Proposed
182# OPEN
DECK

Kopp #
7301 BROWNS BRIDGE RD.
FULTON MD 20759.

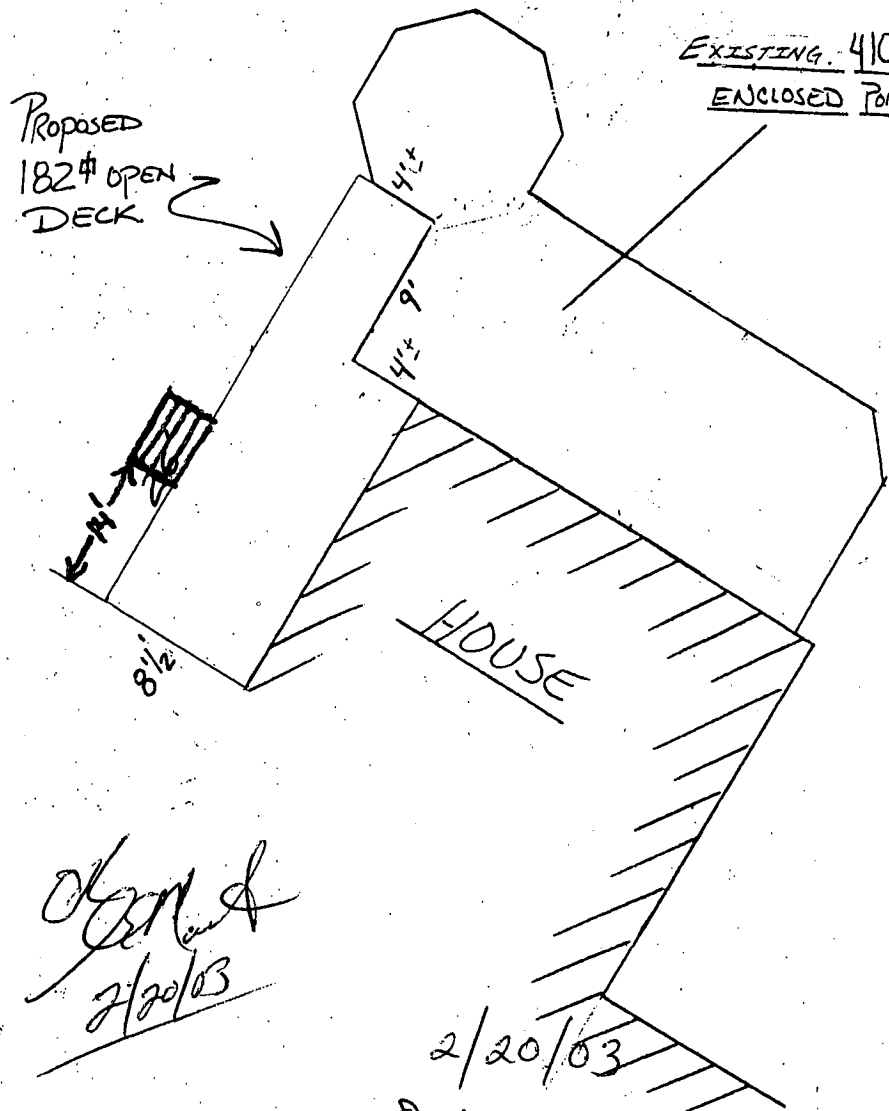
11/12/02-
Proposed deck
OK SRK
10' from trenches

~~OK~~ to Proposed
deck should be O.K.
with steps adjusted
towards house.
Should be ~5'
to septic tank
